Keystone RV Company

SAFETY ADVISORY # 22-427

Norco Coupler Welds

NORCO INDUSTRIES APPROVED INSPECTION PROCEDURE

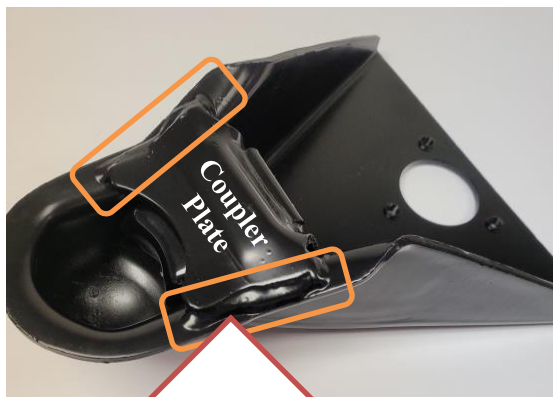
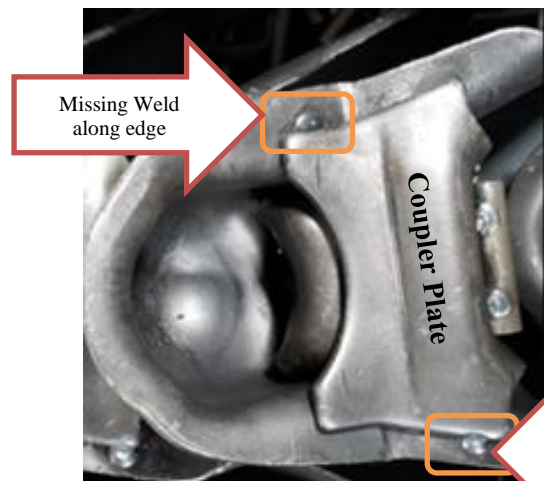
- 2) Underneath the coupler, use a flashlight to inspect the welds at each side of the bottom coupler plate.
- a. To Pass Inspection: A weld bead should run along each side of the plate.
 - b. To Fail Inspection: A weld bead will not run along the side of the plate and there will only be tack welds

Weld
along
edges

Missing Weld
along edge

Tack Weld
Only

STEP 2: REPAIR IF VISUAL INSPECTION FAILS

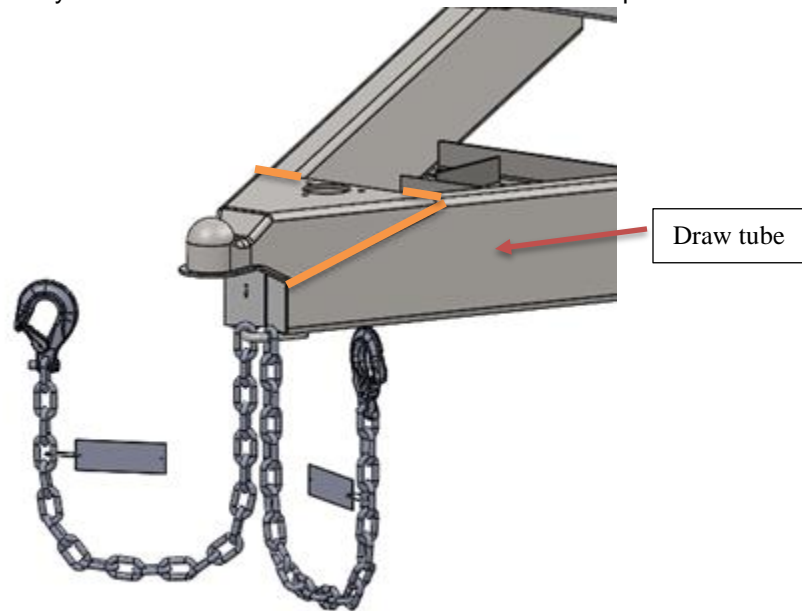
- 1) In a circumstance that the coupler is only tack welded on the underneath plate, the coupler will need to be replaced by a qualified welder.
- 2) Safely support the front of the RV with jack stands and remove the tongue jack.
- 3) Carefully cut through the perimeter welds of the coupler allowing the defective coupler to be removed. *Use caution not to damage the draw tubes when cutting through the welds.*
- 4) Using a grinder, remove any excess weld from the draw tubes once the coupler has been removed.

- 5) Prep the replacement coupler by removing the paint from the weld locations.
- 6) Weld the replacement coupler in place just as the original was welded.
- 7) Paint raw steel areas.
